# Memorandum

FROM: Hayes Taylor, City Planner

DATE: October 27, 2025 (Amended October 29, 2025)

CASES: 2025-CD-RZ-03, 2025-CD-RZ-04 & 2025-CD-VAR-01

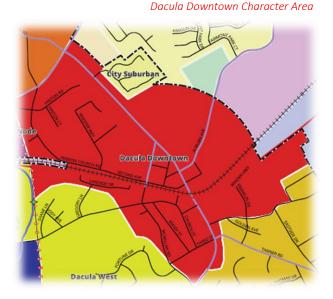
The applicant additionally requests the rezoning of the remaining ±0.71-acre from the current zoning districts to C-2 *DOD* (General Business District, *Downtown Overlay District*). To the south, the old downtown Dacula strip dating back to 1800s along Second Avenue, directly abuts the assemblage. The submitted concept plan is similar to the site design of the existing downtown Dacula, and would be consistent with Second Ave.'s current built-form. The internal pedestrian extension and proposed plaza fronting Second Ave. would tie into the existing pedestrian traffic, providing a natural extension of retail space. The proposed pedestrian path, plaza and courtyard further conform to the objectives of the Downtown Overlay District, and meet the 15% civic space requirement for redevelopments above 3-acres.

The applicant additionally requests two-curb cuts within 300 ft, the waiving of the build-to-zone, and front-loaded off-street parking. The subject property's topography would likely prevent the inter-parcel access between the rowhouse neighborhood and the proposed commercial units. Thus, decreasing the feasibility of the commercial units, should an additional curb cut not be allowed.

The submitted concept plan complies with the intent and purpose of the DOD. The proposed internal pedestrian path and orientation of the new commercial units away from the right-of-way lends itself to the front loading of the shared parking area along Wilson St. These circumstances and the requested variances could serve to promote the goal of downtown redevelopment. Given the hardship derived from the topography and the nature of the unique pedestrian site design, staff recommends approval of the requested variances.
